**TYSOE PARISH COUNCIL**  
**Response to Planning Application**  
**22/02935/FUL**

**Tysoe Parish Council object to application 22/02935/FUL in the strongest possible terms.**

- 1.1 This statement of objection is being submitted on behalf of Tysoe Parish Council in respect of planning application 22/02935/FUL, an application made by Acorn Bioenergy Ltd for the construction of an anaerobic digestion facility, comprising silage clamps, digester tanks, lagoons, administrative buildings, landscape and access on land north of A422 and south-west of Tysoe Road, Butlers Marston.

Map illustrating location of viewpoints - comparison between Tysoe PC and SLR

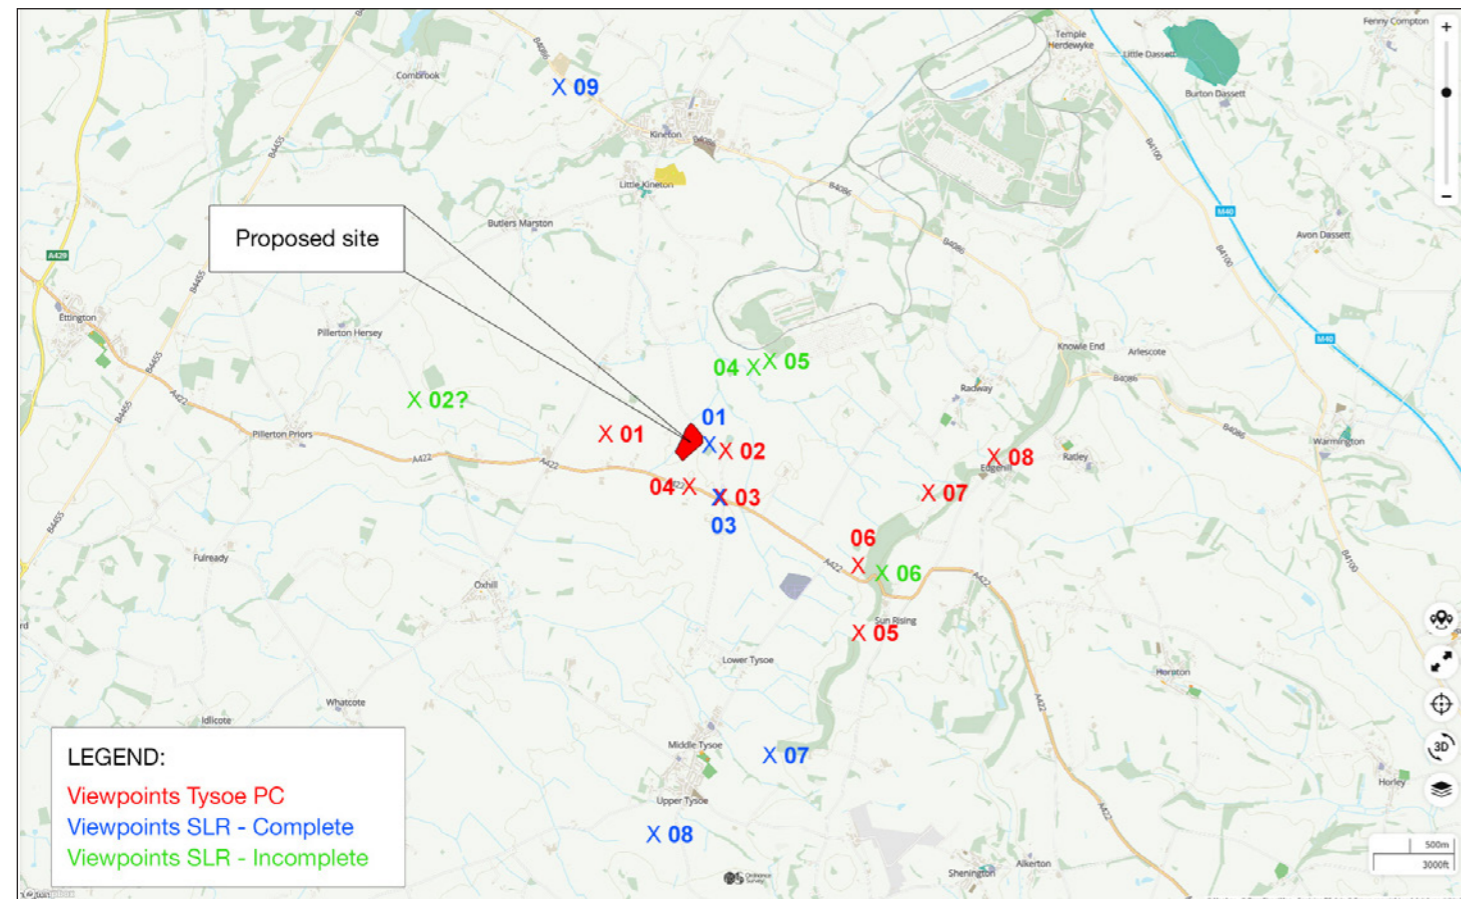
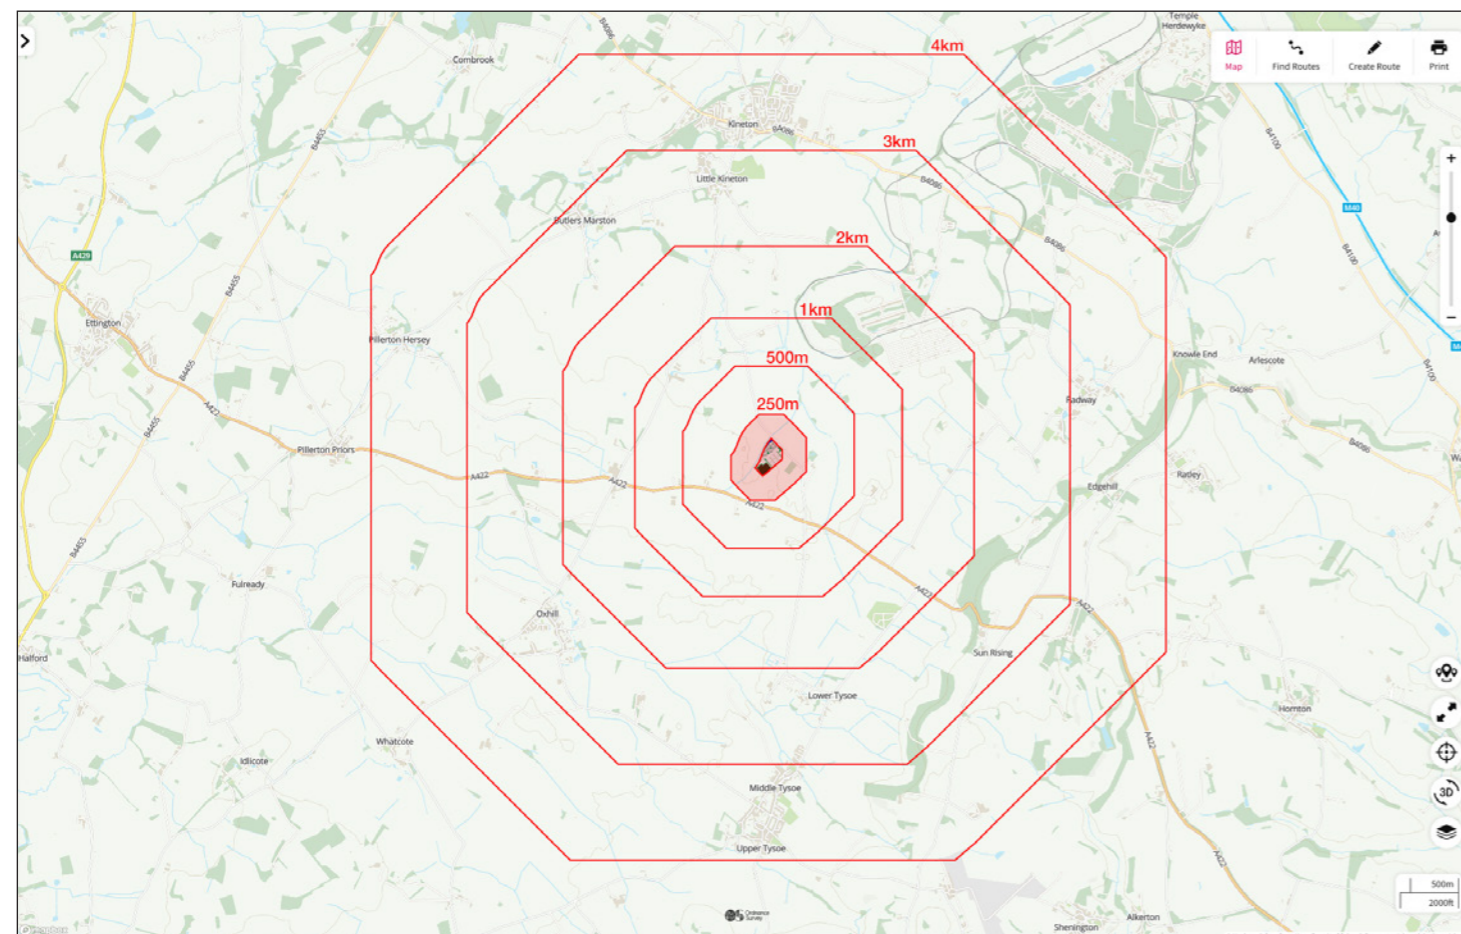
This sets out the findings of a review, undertaken by Zanna Consultancy & Design, of the wireline viewpoints created by SLR within the 'Appendix 2 of the LVIA - Landscape photos'.

Referring to 'Appendix 2 of the LVIA - Landscape photos', SLR's wireline viewpoints are misleading, inaccurate and incomplete. See numbering in blue and green on the map illustrating location of viewpoints:

- Viewpoint 1 - Complete but inaccurate. The buildings are incorrect size and height in relation to the digesters
- Viewpoint 2 - Incomplete as no wireline has been created. Unclear where this location is

- Viewpoint 3 - Complete but inaccurate. The scale is incorrect so the digesters and buildings are not high enough
- Viewpoints 4, 5 & 6 - Incomplete as no wireline has been created

In the LVA, SLR state that their photos are: 'non-verified Type1 photographs informed by guidance produced by the Landscape Institute. The existing views were recorded at the position of each viewpoint using a Nikon D610 full frame camera and a fixed 50mm. The camera was set 1.5m above ground level. The photographs were stitched in PTGUI and cylindrically projected to reflect natural vision and proportion.' I question this statement for the following reasons: SLR state that they use Type 2, not Type 1, on their wireline document; I do not believe that a fixed 50mm lens has been used; and stitched photos cylindrically projected are, in my opinion, unnecessary for a development of this type. The stitching refers to panorama style imagery where you stitch several photos together to get one very wide image, this would only be necessary if you couldn't get the whole site in to one photo, for example if it was a very large scale windfarm with a site several miles wide.

Referring to the 'Landscape Institute Technical Guidance Note - Visual Representation of Development Proposals' document, I have used the methodology from Type 3 visualisation, but SLR state on their wireline document that theirs are Type 2 visualisations. In 4.1.2 it states that 'Whilst Type 3 will be acceptable in many situations, only Type 4 methodology and equipment can provide the levels of verifiable accuracy which are appropriate to high Sensitivity contexts and Purposes.' I do believe that this is a 'high sensitivity context' and as such, their visual representation should be of Type 4. I do not have the technical equipment required for this (LiDAR, measured surveys, tripod and camera with a full frame sensor), hence Tysoe PC's being of Type 3.

Referring to '3.8 Viewing Distance and Enlargement Factor', I question SLR's odd choice of 96% at A1 rather than the recommended 100% at A3. In particular, I believe they have used a similar set up as stated in 3.8.15 - using a 35mm (wide-angle) lens and printing at A1 size. When I look at their photos I believe they are actually shot with a wide-angle lens - the distortion of the foreground is indicative of this. 3.8.16 goes on to state that the 'practitioner should ensure that image quality is appropriate for purpose'. I do not believe that SLR's are appropriate for purpose. Most of the photographs are too far away, incomplete or inaccurate.

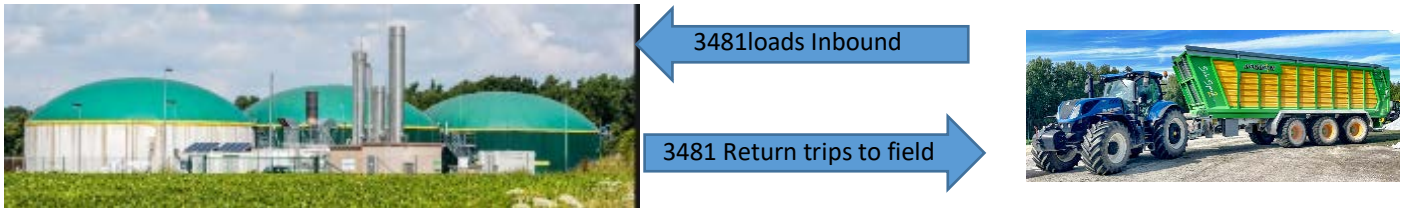
On table 6-1 on page 27, Transport Statement, Acorn have failed to conduct correct calculations in their own document and underestimate their stated trips, giving false and misleading figures.

- 6.7 Also, in table 6-1 on page 27, transport statement 'LNG' is in the export section, but on page 26 under 6.2.3, Imports, the following is quote, "The site will also import Liquid Natural Gas (LNG) to power the on-site natural gas CHP as grid connection at this location has not been possible". Error on calculations and misleading figures.

- 6.8 When looking at figures for TPA (tones per annum), for Biomethane, Co2 and LNG, under export in table 6-1, page 27 of the transport statement, Acorn have submitted errors, and false information on transport trips. This follows from the corrected calculation based on the figures submitted by Acorn within this table for planning.

**Figure 1: Location of Proposed AD Plant and Hardwick House and Hardwick Barns**

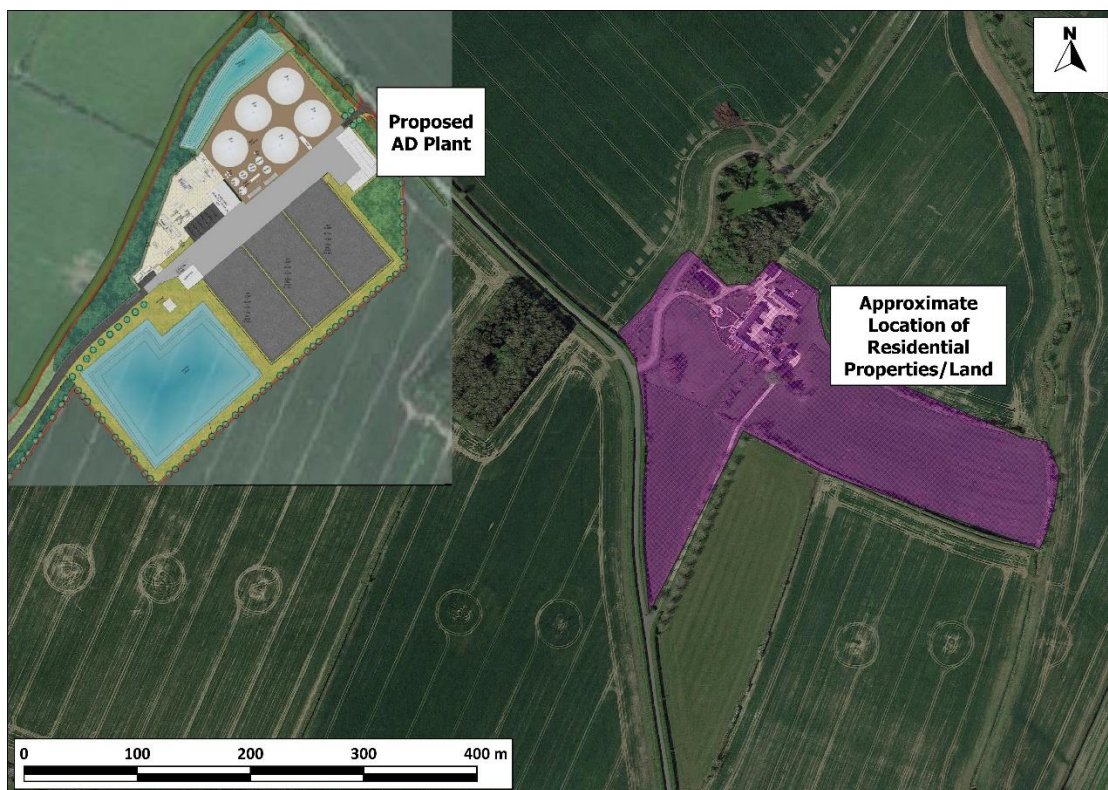
- 1.2 The residents of Hardwick House (one property and associated land) and Hardwick Barns (comprising five properties and associated land) located approximately 200 m to the east of the proposed AD plant at the nearest boundary have expressed concerns regarding the potential for adverse odour impacts at their property resulting from the operation of the proposed facility. The location of the proposed AD plant in relation to the nearby residential properties is shown in Figure 1. AQC has therefore been commissioned to undertake a detailed review of the methodologies and assumptions employed within the odour assessment (SLR, 2022), and to review them against the approaches set out in relevant published guidance documents in order to determine the robustness of the assessment approach and whether the overall conclusions are valid and can be relied upon.
